E1460A-01

S E R V I C E N O T E

E1460A 64 Channel Relay Multiplexer

E1460A may fail to open/close relays because of a defective relay driver IC with date code 0325.

PCA PN: E1460-66702

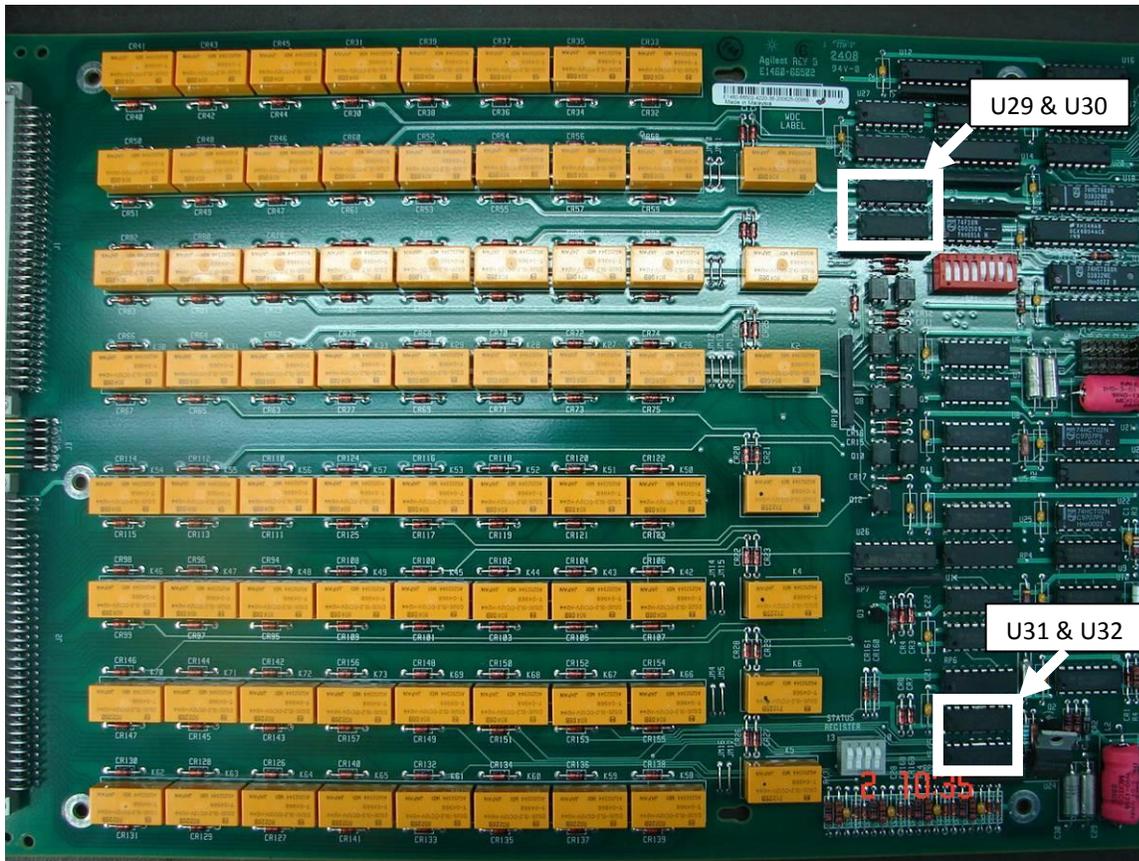
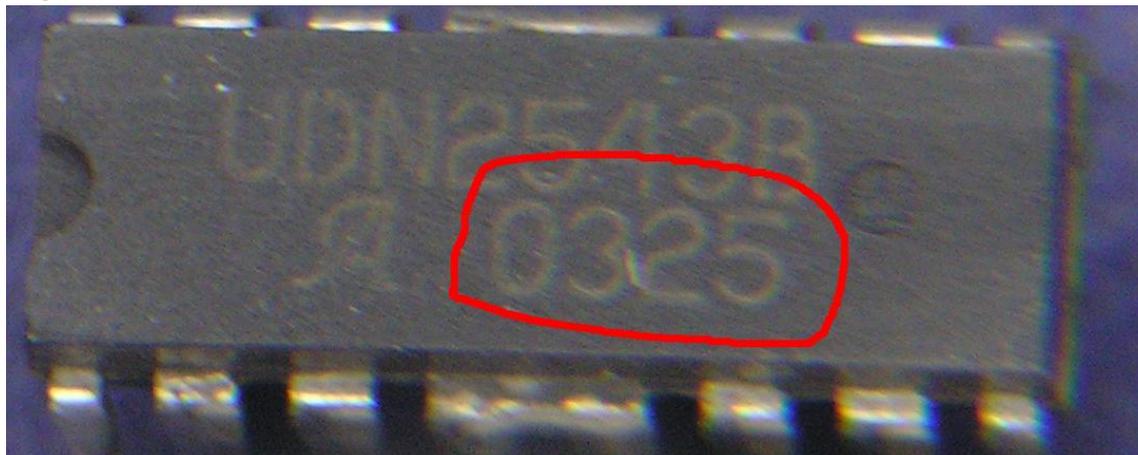
The relay driver ICs are U29, U30, U31, U32 which are the LTB part 5188-2550 for 1820-4599. The bad date code is 0325. This date code has a higher than normal failure rate. Most failures have occurred in the first three months of usage. See the following pictures for part and date code location

Location Impacted: U29, U30, U31 & U32

A E1460A that fails to close or open it's relays and has the 0325 date code ICs should be replaced with a E1460-66702.
